Engineering Change Notice(ECN)

ECN-D-2604-11

(Buffer jig change from 300.3mm to 301mm)

FA Research ME 1 Team

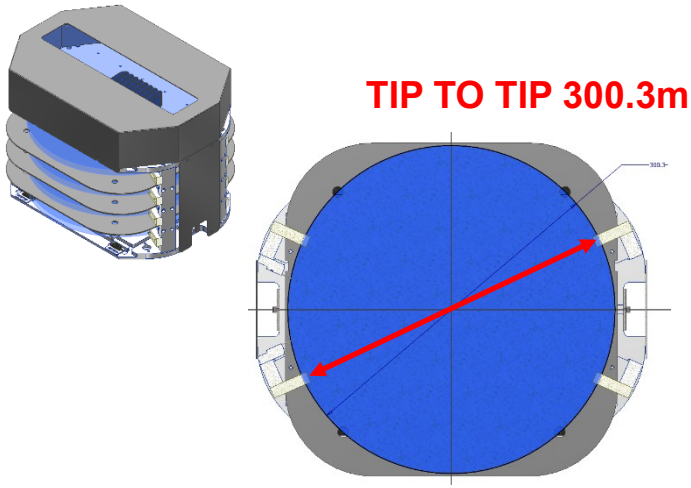
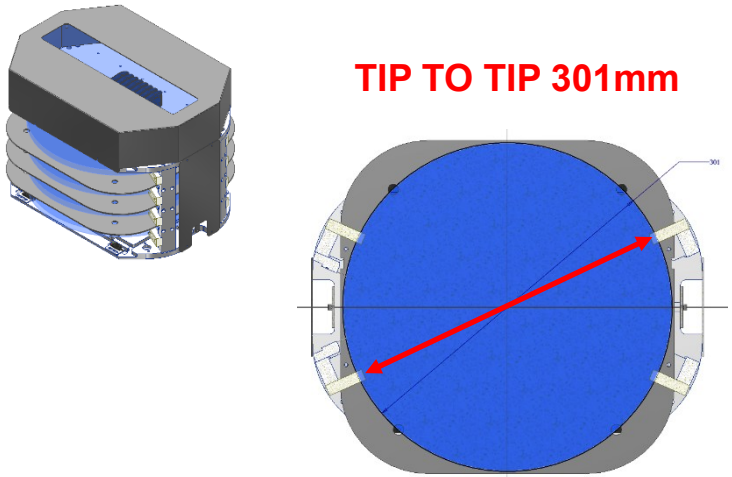
Before(Problems and Change Requests)	After(Expected Effect)
Problems: The gap between wafer and buffer tips is a litter small when we use 300.3mm buffer jig to adjust buffer tips. In this instance, robot maybe put the wafer on buffer tips. Request: Change the buffer jig from 300.3mm to 301mm, and use the 301mm buffer jig to adjust buffer tips from now.	Expected Effect: ACM will use 301mm buffer jig to adjust all existing buffer, and the 301mm buffer jig will be applicated in NB factory.

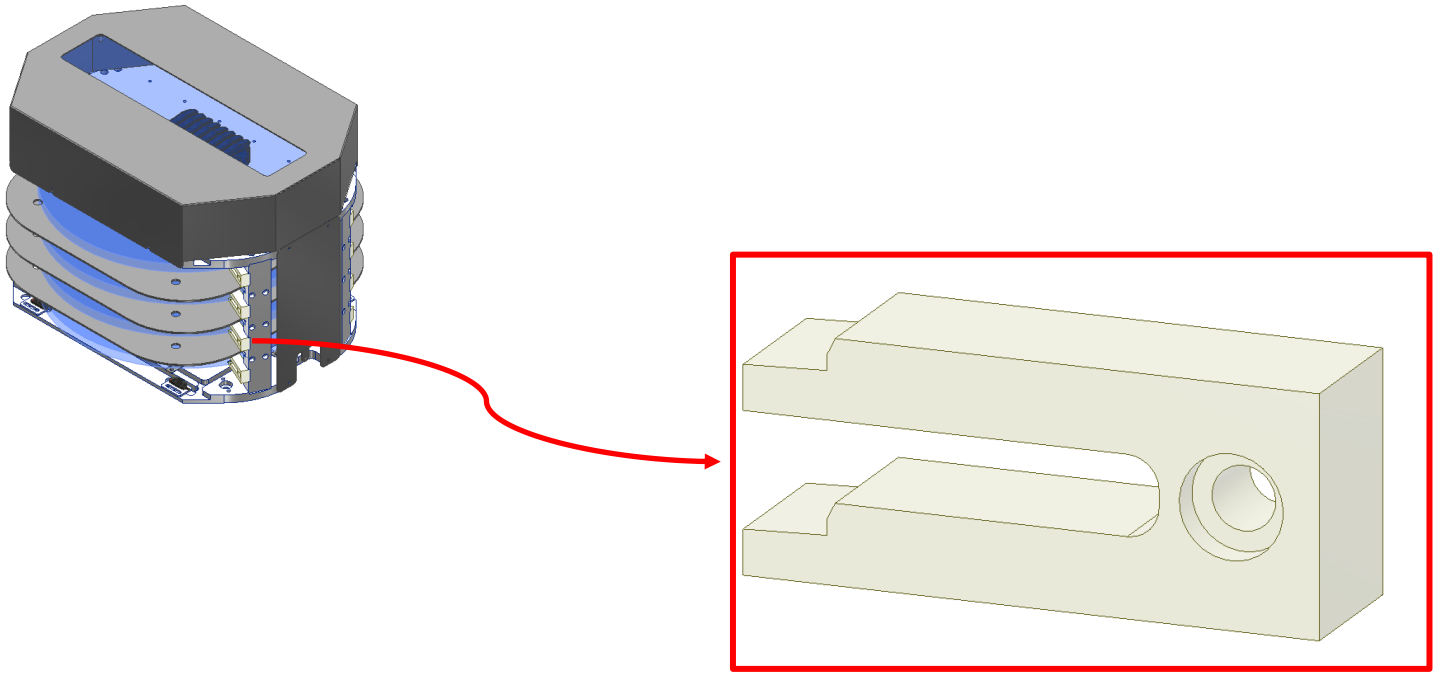
적용 장비 타입 Applicable project type	Buffer (All)	적용 범위 Scope	■ 신규 발주분 (New order) □ 기발주분 (Previous order) □ 기출하장비 (Existing shipped equipment)
변경 사유 Reason for change	■ 고객 요청 (Customer request) ■ 품질개선 (Quality improve) □ 원가절감 (Cost reduction) □ 생산성 향상 (Increase productivity) □ 부품 단종 (Part discontinuation) □ 기타 (ETC)	ECR NO. ECN NO.	ECR-S-2603-06 ECN-D-2604-11
변경 상세 사유 Detailed reason for change	The gap between wafer and buffer tips is a litter small when we use 300.3mm buffer jig to adjust buffer tips. In this instance, robot maybe put the wafer on buffer tips.		
변경 사항 Changes	변경 전(Before)	변경 후(After)

상세내용 Detail	웨이퍼 측면에 닿는 버퍼 tip간격 300.3mm The spacing between the buffer tips that contact the wafer edge is 300.3 mm.	웨이퍼 측면에 닿는 버퍼 tip 간격 301mm The spacing between the buffer tips that contact the wafer edge is 301 mm.
